FACPAC Contract Change Order Supplemental Information Form (Ref# 50856)

Project: New Spottsville ES

3-8

Additional cost for removal of unsuitable soils and replacement with stone and associated storm system. Cost to install the stone loop road around perimeter of existing school. Installation of owner requested swale at rear of new school to prevent potential ponding in the future. Rock wedge installation per the state building inspector for ADA compliance.

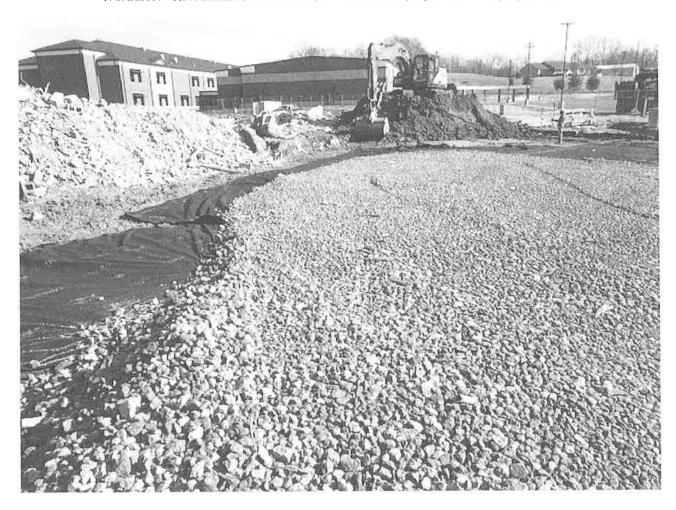
On 12/22/18 & 12/24/2018 we ran into an area of saturated material under the building slab. In order to continue progressing the schedule during Christmas break, we went ahead and undercut an area approximately 4,000 sf to a depth of 18". We documented the work in the attached photos for your review. Hazex appreciates your consideration in approving this change of work.

- a. Supply and install 457.80 tons of #3 stone
- b. Supply and install 1 roll of geotextile fabric
- c. Supply and install 100' of 4" perforated sock pipe.
